P12/V1819/0  
APPENDIX 1

CONSULTATION WITH CUMNOR PARISH COUNCIL

Application reference: P12/V1819/O  
 Application type: Major  
 Address: Land to the rear of No's 82-88 Cumnor Hill, Oxford OX2 9HU

Proposal: *Outline application for the erection of a 72 bed residential care home and 4 units for staff accommodation with associated parking, landscaping and access.*

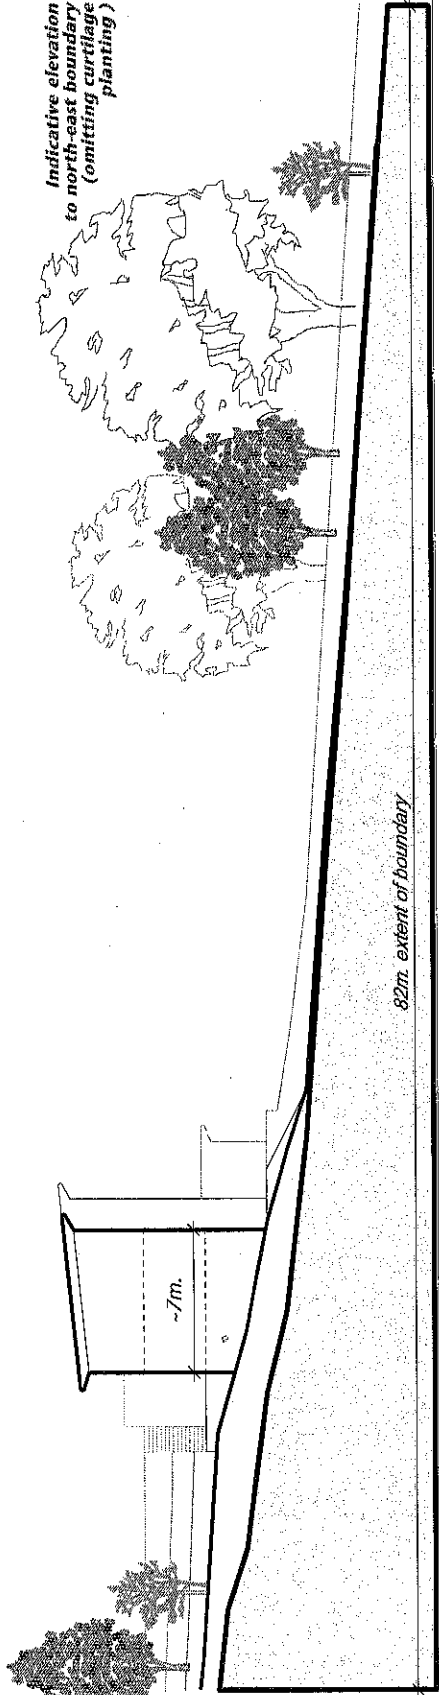
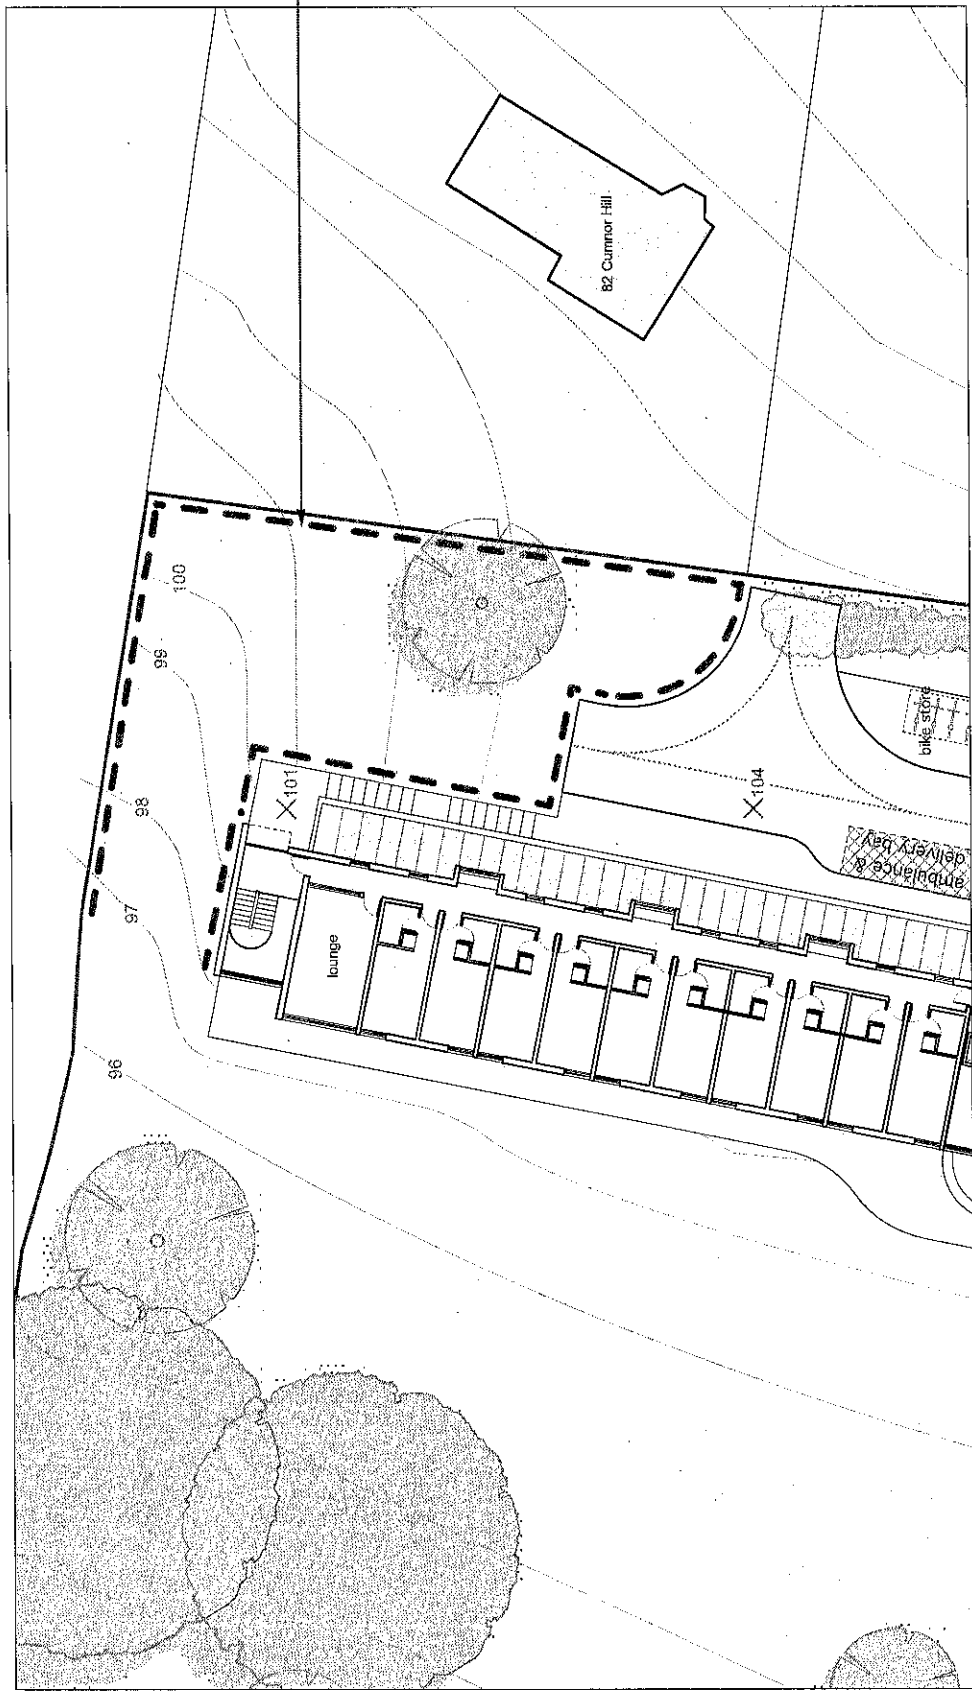
**Safeguarded landscaped badger area:**  
 -service block removed/relocated  
 -access road shortened  
 -external steps to flank removed
